50-286

APPENDIX
TO
COMMENTS OF CON EDISON
ON
DRAFT ENVIRONMENTAL STATEMENT
RELATED TO THE OPERATION OF
INDIAN POINT NUCLEAR GENERATING PLANT
UNIT NO. 3

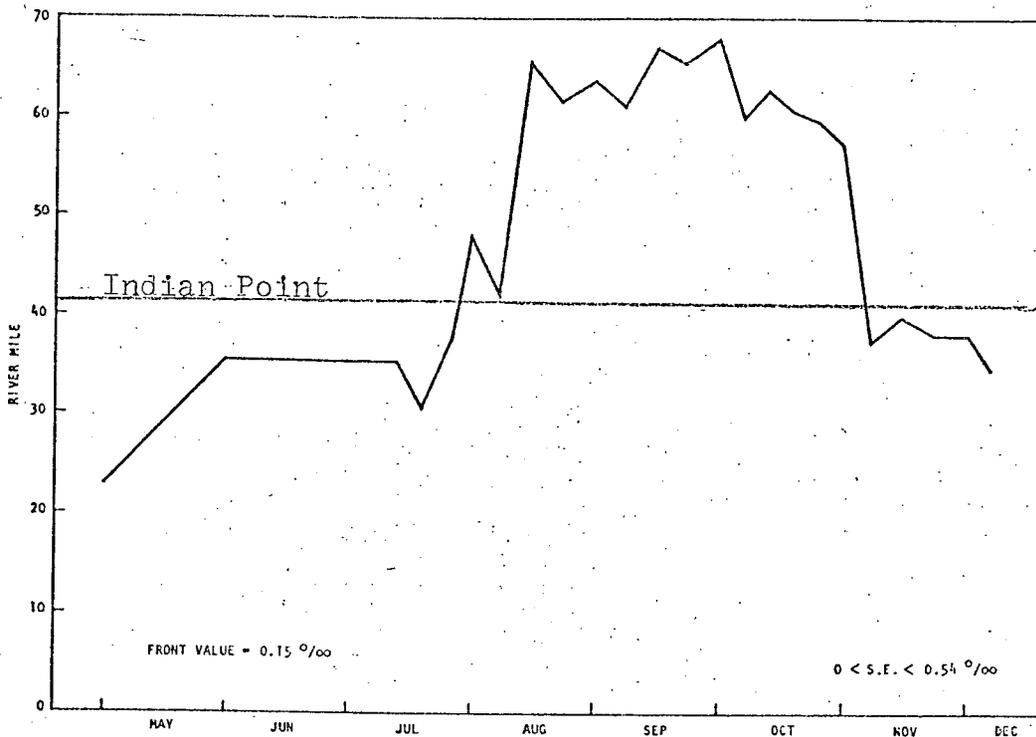
The important geographical features in Figure II-1 should be included in the text.

157. Page V-80

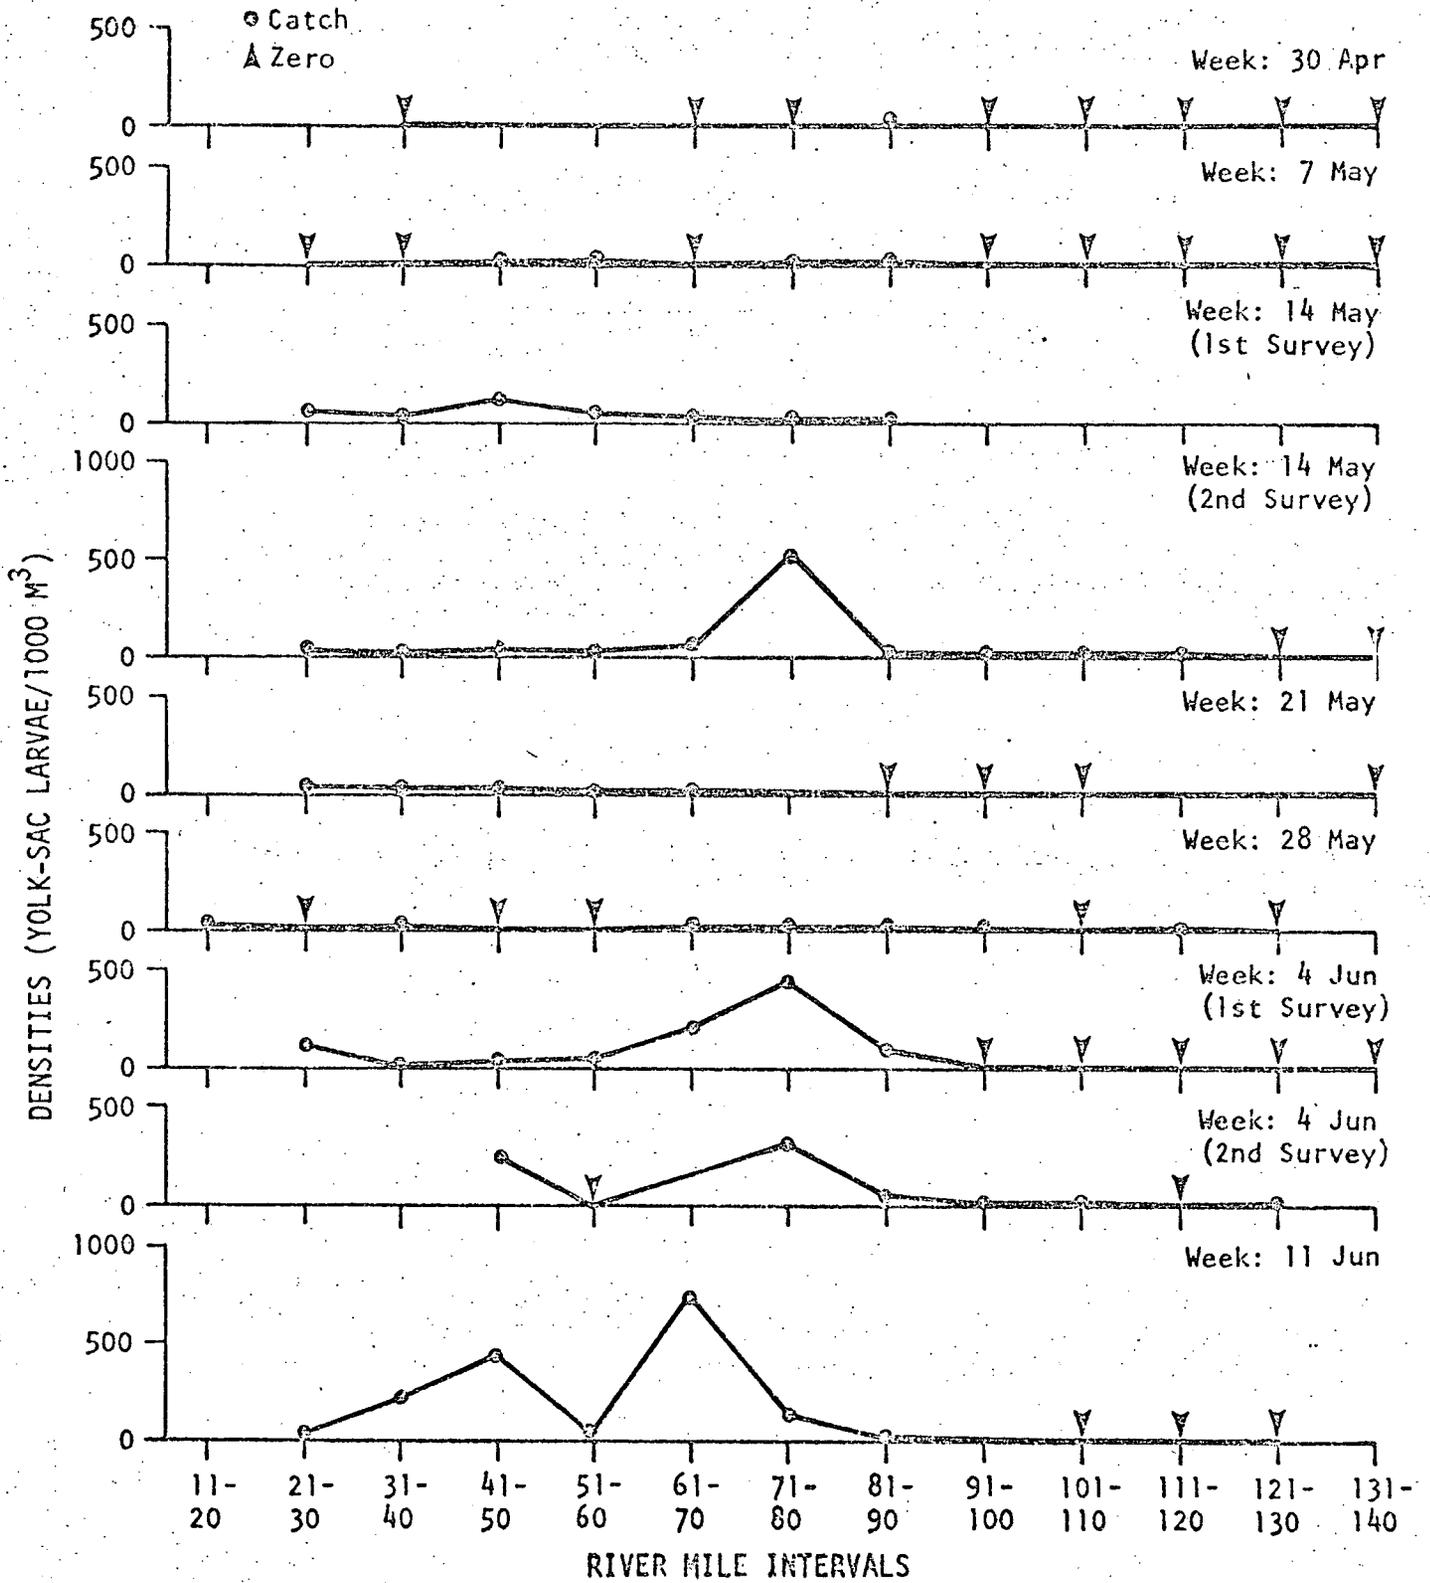
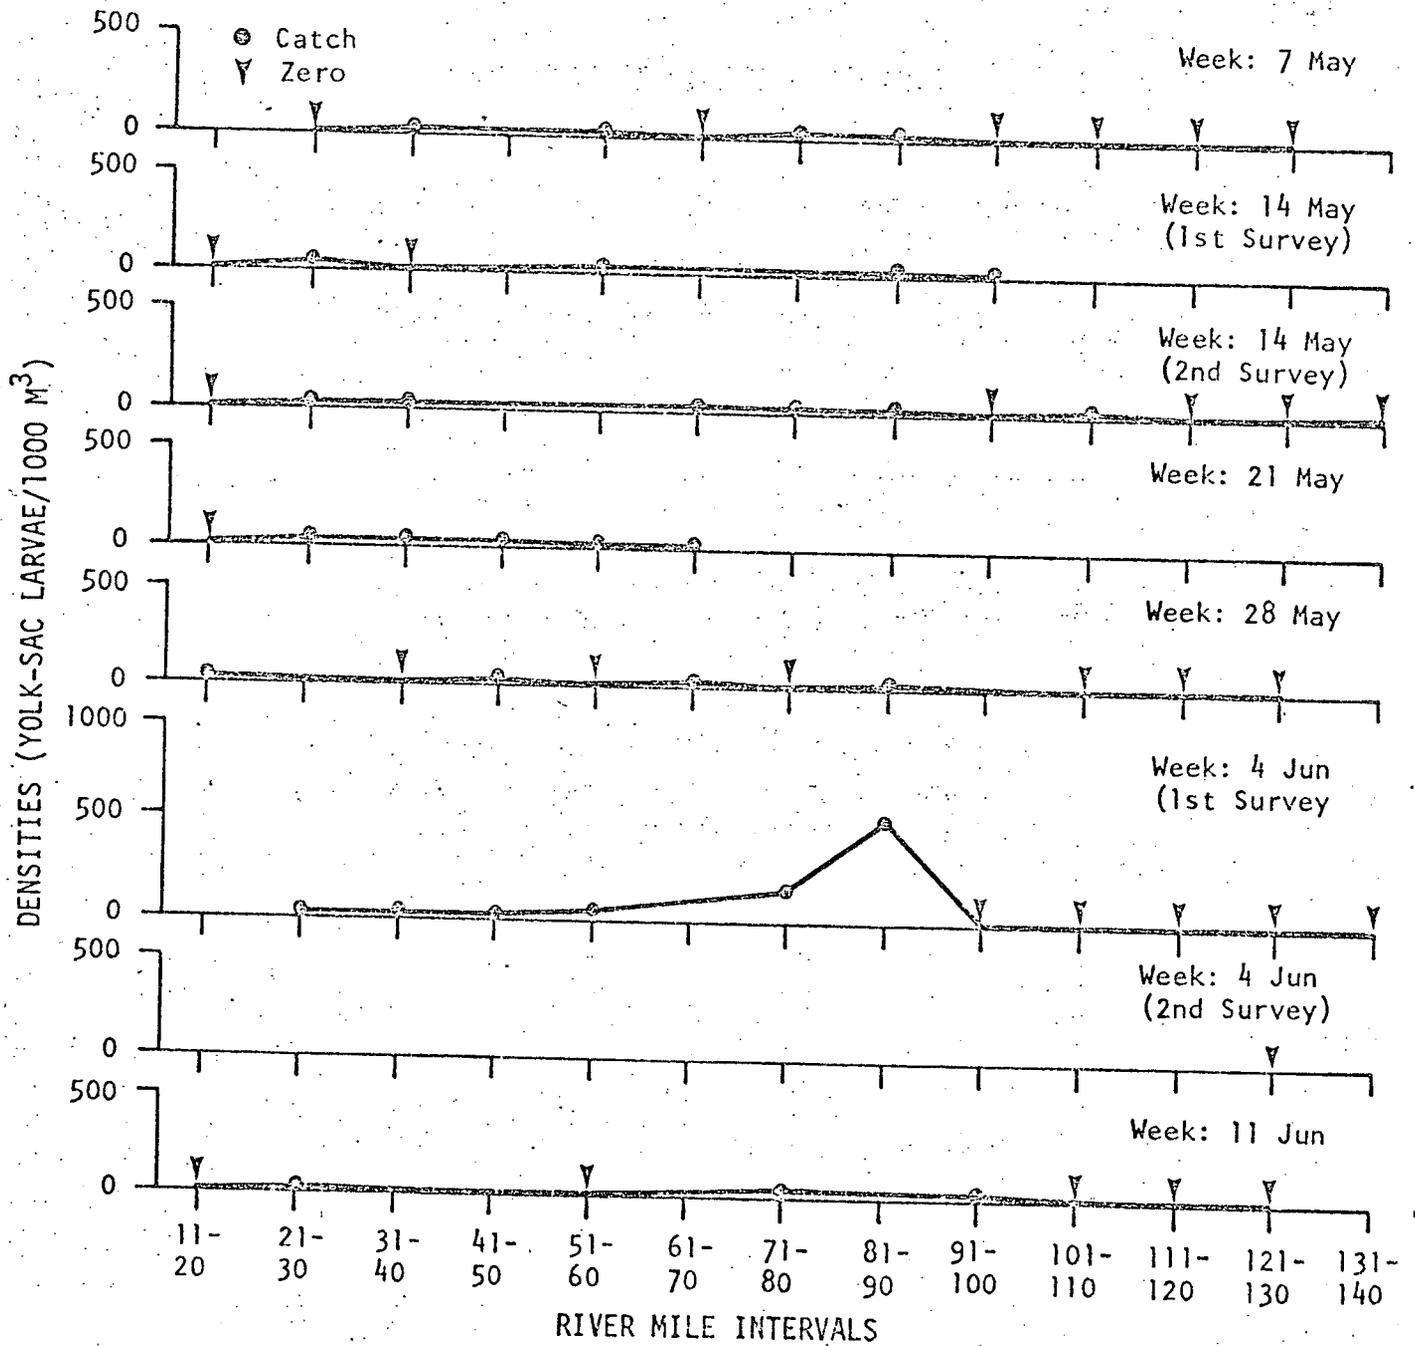
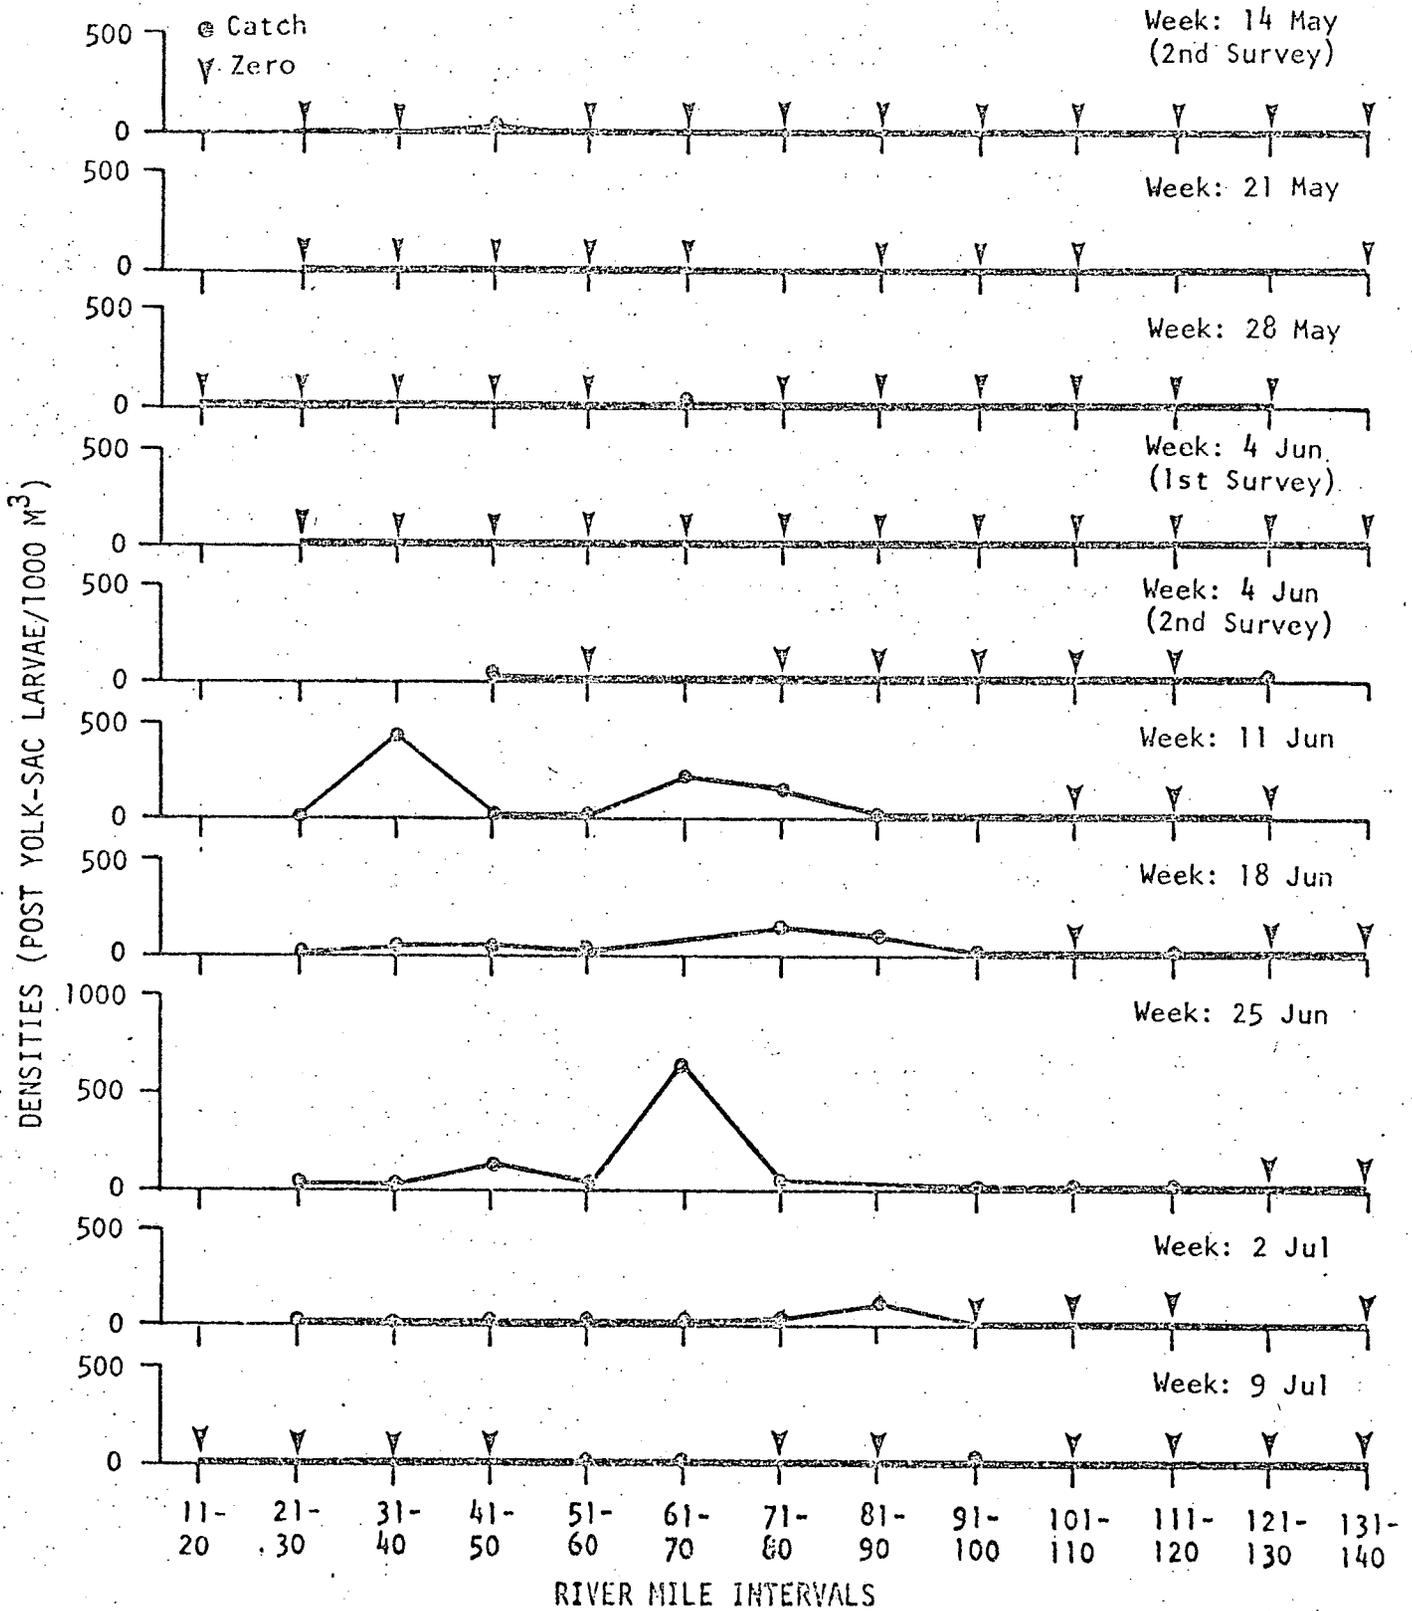
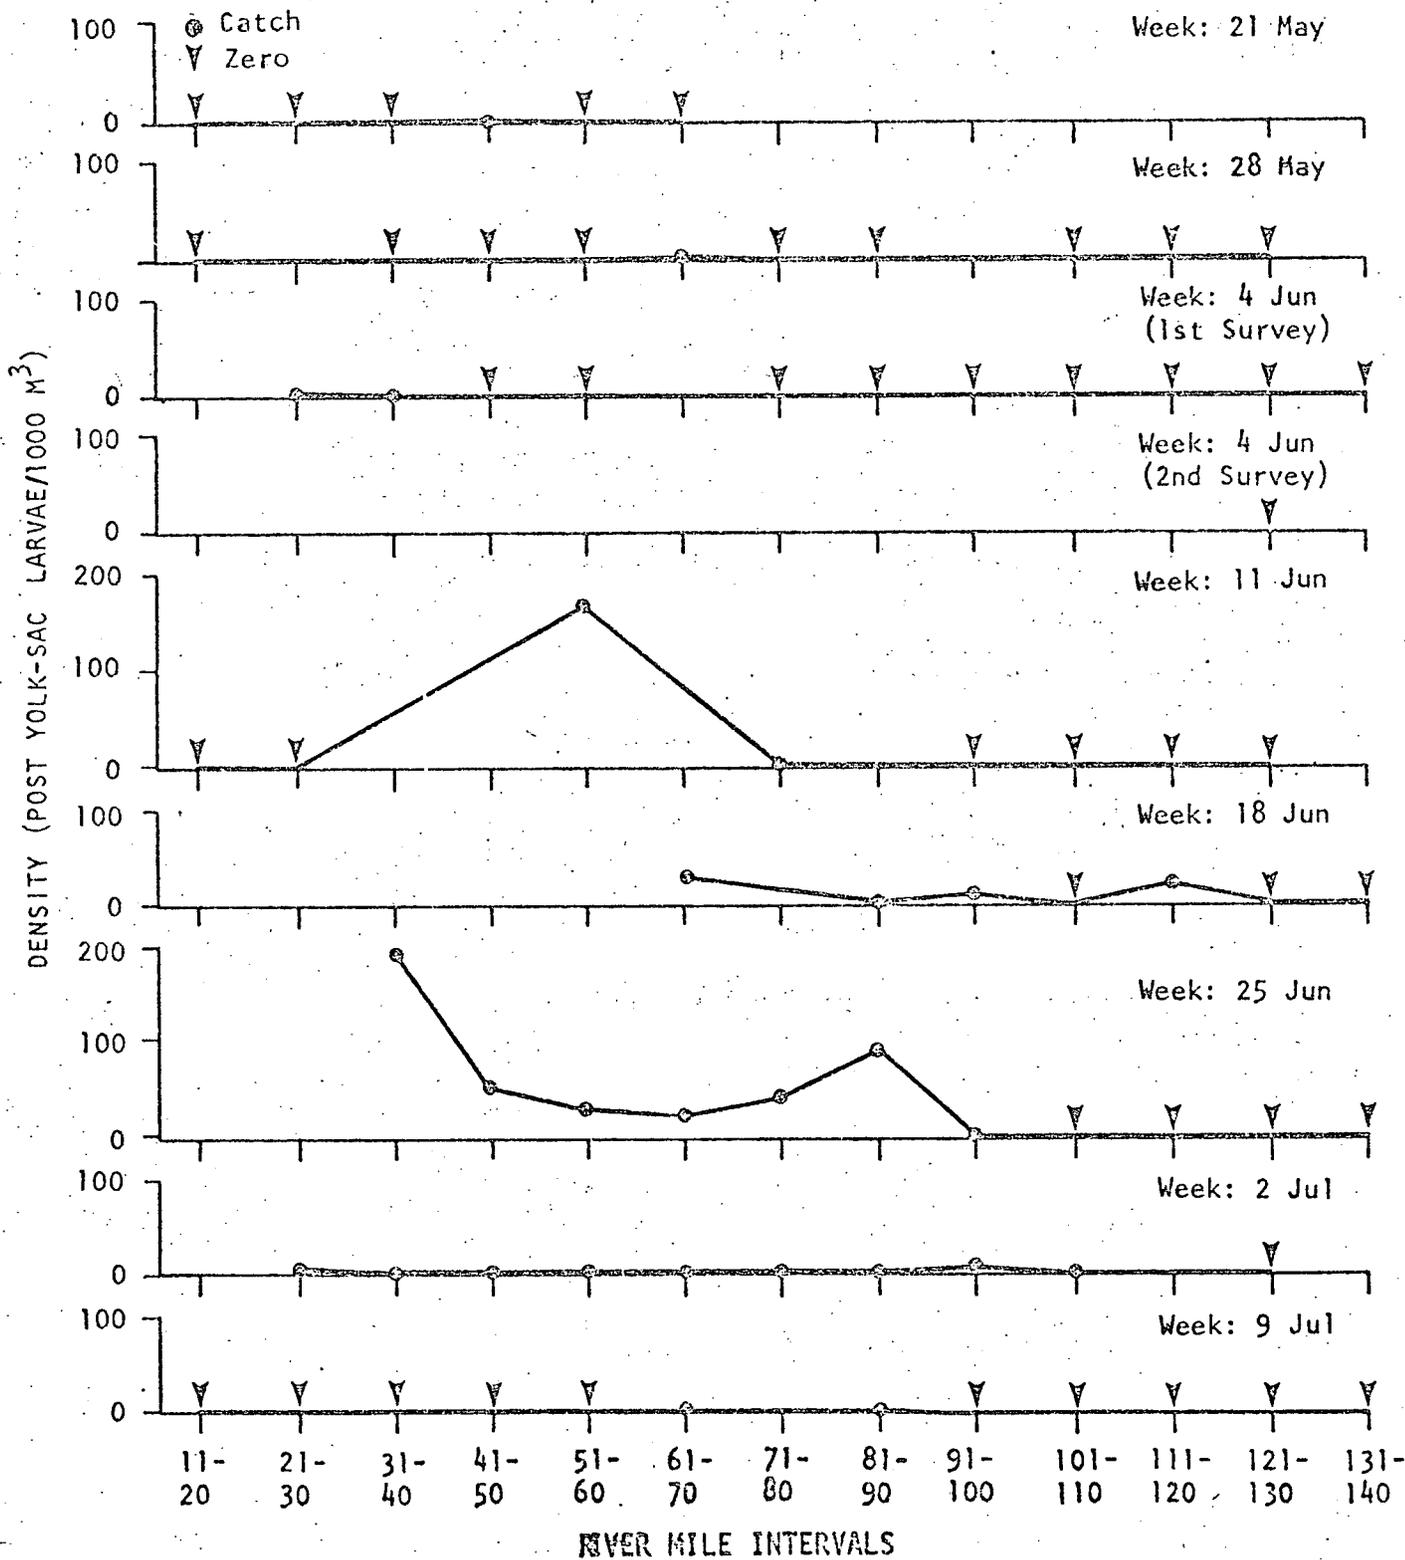
Attached are updated charts showing spatial and temporal distribution of striped bass eggs and larvae in 1973. These should be substituted for the charts on page V-80.
